Seabrook Station ASR Methodology LAR: Structural Deformation

LAR 16-03

Methodology and Responses to RAIs D2-D8

November 17, 2017

Parametric Study 1- Stress in tension rebar of typical 2 ft thick member subjected to P-M and increasing ASR strain

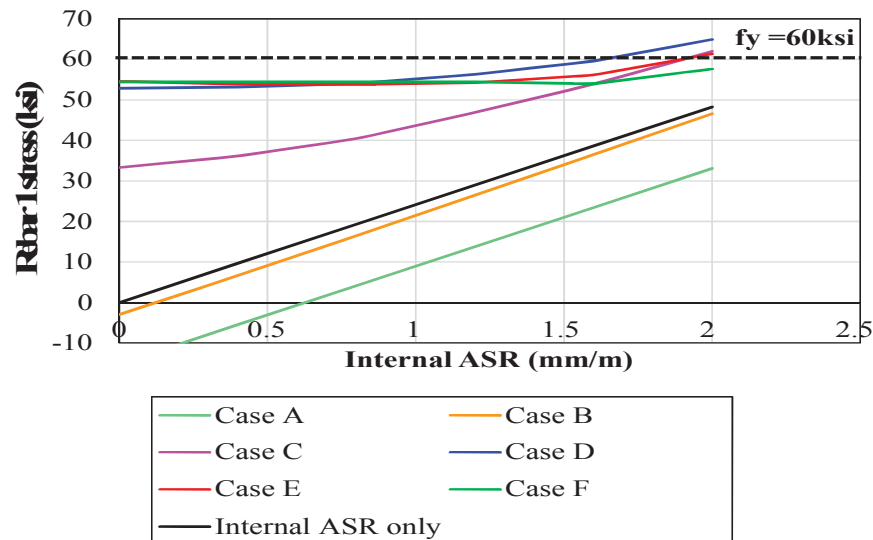
- **Performed two parametric studies to examine rebar stresses.**
 - Scope
 1. Effect of increasing ASR expansion for member subjected to external load.
 2. Impact of increasing load on ASR-affected member.
 - Preliminary results for discussion
 - Rebar stresses remain in elastic range for normal operating (service) loads.
- **Assessed rebar stresses for Seabrook structures.**
 - Scope
 - Structures evaluated to date
 - Preliminary results for discussion
 - Stresses and strains in the Seabrook structures are shown to be within elastic limits under normal operating load conditions (unfactored loads) when ASR loads are considered.

- The tensile stress in the rebar increases after ASR expansion is sufficient to close structural cracks around the tensile rebar.
- For sections with already high levels of external load (factored level loads), high levels of ASR are needed to cause additional tensile stress in rebar.
